SUBJECT: Joe Dhaliwal
Rezoning, Development Variance Permit
& Development Permit / 7990 Lickman
Road

DEPARTMENT: Planning Department
RZ001662, DVP01343 & DP001712

**STAFF REPORT ON REZONING RZ001662, DEVELOPMENT VARIANCE PERMIT DVP01343 &
DEVELOPMENT PERMIT DP001712 APPLICATIONS**

Parking Space Overhang

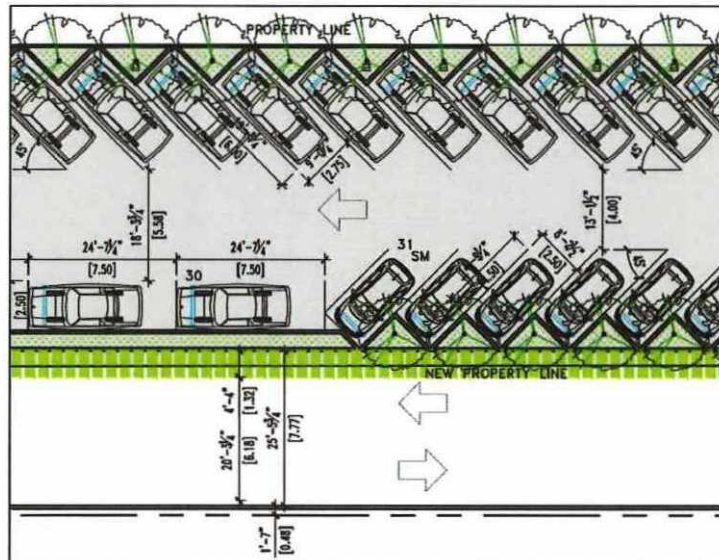
The applicant requests to waive the requirement to provide a 0.6m landscape bed for vehicle overhang when a parking space is located adjacent to a building, fence or sidewalk in various location throughout both the industrial and hotel lots. As shown below in red, within the industrial lot, 6m long parking spaces have been provided at each end of building 2 and 3 without a raised landscape bed. For the hotel lot, a portion of the sidewalk along the west property line narrows to less than 0.6m. In addition, the spaces located along the east property line do not have a 0.6m buffer adjacent to the hotel's garbage enclosure.

The applicant also requests to waive the requirement to provide a 1.5m wide sidewalk located outside of a maneuvering aisle. To ensure pedestrian connectivity is provided from Lickman Road, the applicant has provided a 1.3m wide painted pathway located within the required 7.5m maneuvering aisle as highlighted in blue above. The Zoning Bylaw requires pedestrian pathways to be at least 1.5m wide and located outside of maneuvering aisles. Given the constraints related to the existing orientation of the lot, the applicant has indicated they are unable to provide a separate pedestrian pathway from Lickman Road given the requirements for off-street parking, maneuvering and landscaping. As the surrounding area is primarily industrial in nature, with few amenities within walking distance, pedestrian movement within the site to Lickman Road is expected to be limited. As such, the painted pedestrian pathway will likely be sufficient to manage pedestrian traffic on site.

Landscaping

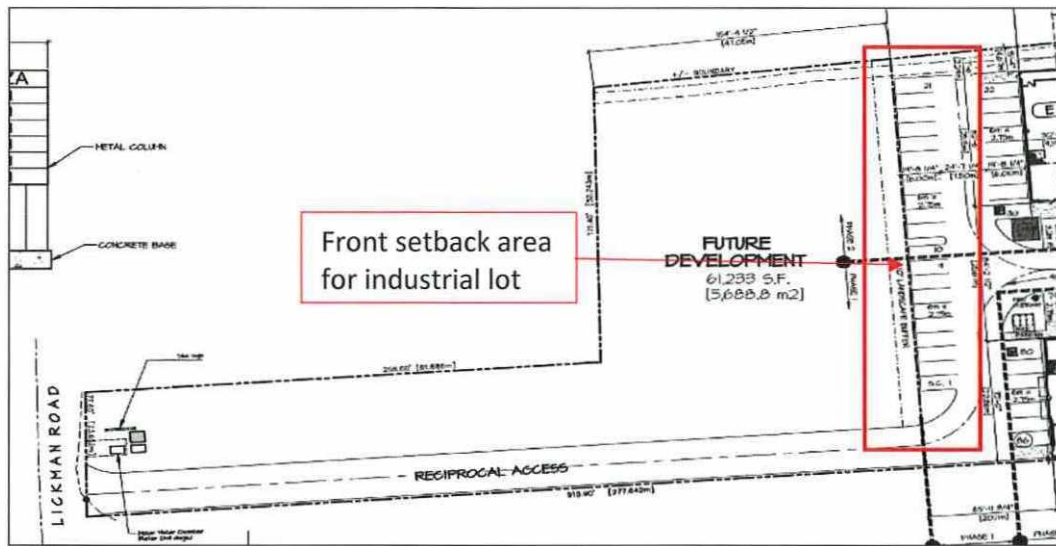
The applicant requests to waive the requirement to landscape the front setback area for the proposed industrial lot only. The Zoning Bylaw requires 40% of front setback area to be landscaped to ensure an appealing streetscape and screening is provided along property frontages. This standard has been met along Lickman Road for the proposed hotel lot, however, the proposed industrial lot does not meet this requirement. As the industrial lot is considered a panhandle, the front lot line (as shown below) is not adjacent to Lickman Road but rather is located to the rear of the proposed hotel site. As such, in order to ensure the two sites include clear access and movement between properties, the applicant has requested to waive the landscape requirement along this shared property line. In addition, as this area is not visible from the street, the requested variance is supportable and not anticipated to impact the surrounding area.

The applicant requests to waive the requirement that landscape beds within parking areas be at least 5m² for the hotel lot only. Given the constraints related to the existing lot orientation, the applicant has provided landscape beds within the panhandle portion of the hotel lot that are only 3.1m². Despite this, the minimum 1.5m dimension requirement is still met and the applicant has provided trees within each bed within structural soil to ensure survival. Further, all minimum landscaping ratios for the hotel lot are exceeded.

The applicant also requests to reduce the minimum interior landscaping of a parking lot area from 7% to 3.7% for the proposed industrial lot only. The overall landscaping requirements for the industrial lot are met; however, only 3.7% of the parking lot area is landscaped. Further, landscaped beds of sufficient size have been provided throughout the industrial lot to break-up the parking area providing visual relief throughout the space.

Building Height

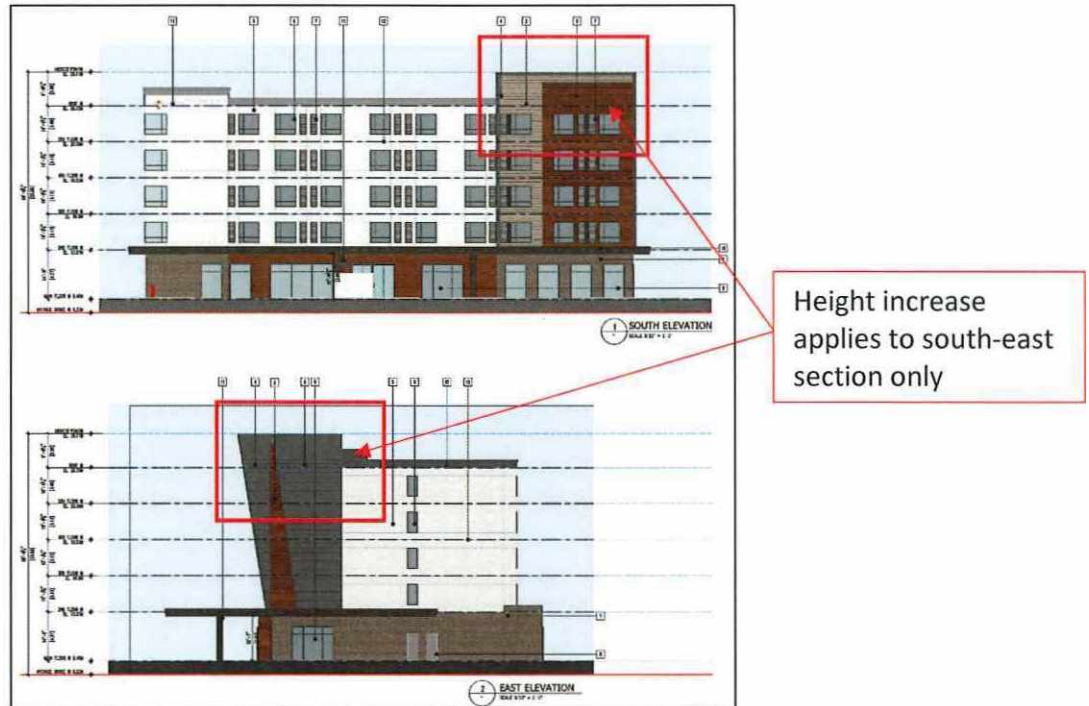
The applicant requests an increase to maximum building height from 20m to 20.9m to accommodate the proposed 5-storey hotel. As shown below, the height increase only applies to the southeast section of the hotel to accommodate increased building articulation and architectural features. As the requested increase is considered minimal and only applies to the architectural feature, the requested variance is considered supportable in this instance.

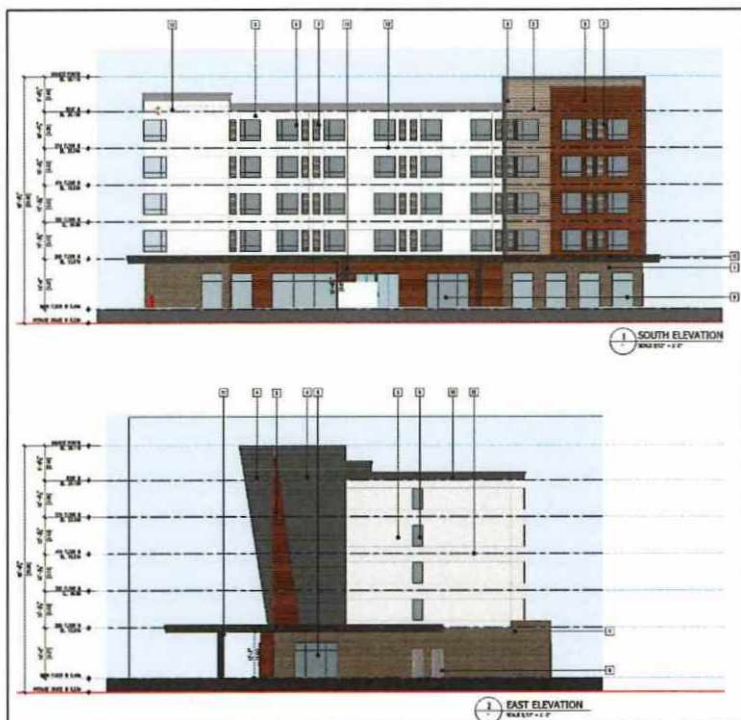
7. *that additional colour and/or materials be incorporated into the southeast corner elevation of the hotel building to create greater visual interest and break up the overall massing of the structure.*

In response to condition 7, the applicant has provided updated elevations, shown below, to ensure additional colour and materials are incorporated into the southeast corner of the hotel. As such, condition 7 has been removed from the draft permit.
